Our Ref: C1806-T1Rev01

Re: Heron House Plant Noise Planning Condition Discharge – Revision 1

Revision Notes: Following review by MCC Environmental Health this revised document addresses comments received.

Responses to EHO comments:

Figure 1: Measurement Positions (1 to 9)

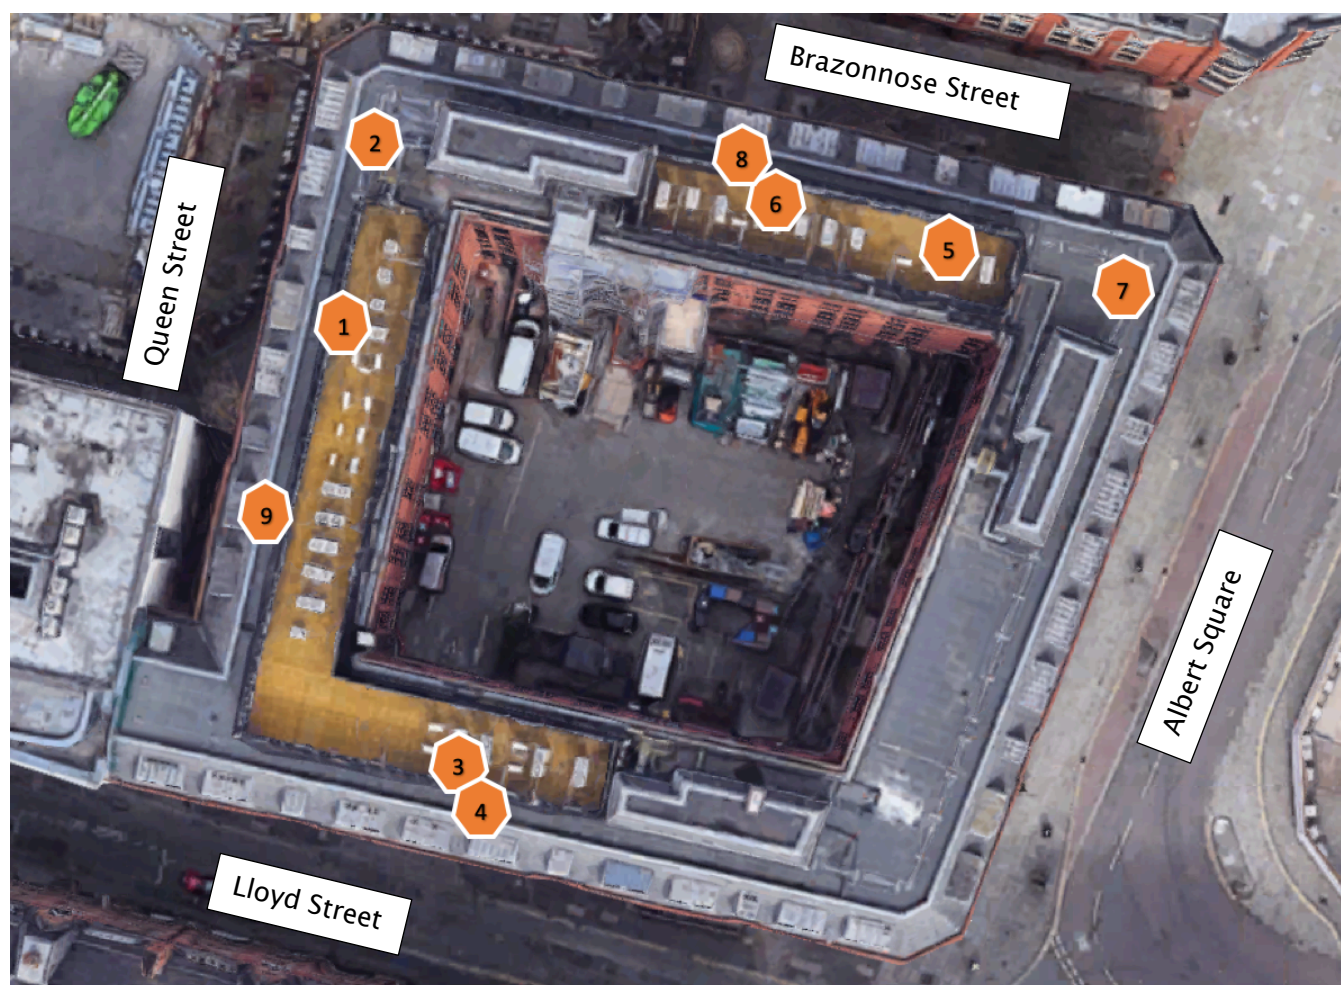
Comment 1	<i>1. The plant rating table needs to include the calculated reduction used for distance in the table</i>
Response 1	Noise reduction (dB) used in the calculation has been added into Table 1. Notes describing elements also added. See Appendix for example of a full calculation.

Plant noise prediction calculations are based on geometric divergence ($20 \times \log(\text{distance})$), taking account of the measurement distances in relation to plant and receptor. Measurements were taken close to the noise barriers (~1m), therefore a correction has been applied to account for the reduced barrier effect at greater distances.

Assessment/Measurement Location (position No.)		Distance – measurement position to Sensitive Receptor (m)	Distance - measurement position to plant (m)	Plant Noise Measured $L_{Aeq,T}$	Barrier effect correction	Distance loss dB $20 \cdot \log(d1/d2)$	Plant Noise Level at Receptor*
Queen Street	Roof edge outside enclosure (2)	12	4	51.3	+2.0	$20 \cdot \log(12/4) = 9.5$	$51.3 + 2 - 9.5 = 43.8 \text{ dB}$

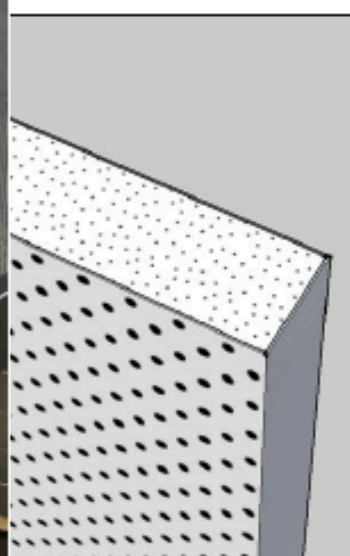
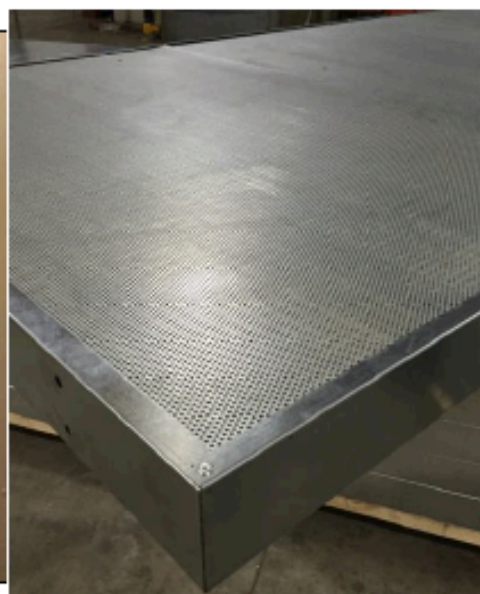
Comment 3	<i>3. We will need confirmation that the noise barrier has been installed as recommended in terms of location, construction, height, materials and acoustic performance along with confirmation there are no gaps. The applicant may have to supply the specification and details of the acoustic barrier installed</i>

Response 3	See appendix for details of the noise barrier specification details, photos showing location and detail. The screens heights average between 2.45m and 2.65m. Note there is slight variation in screen height due to roof undulation.
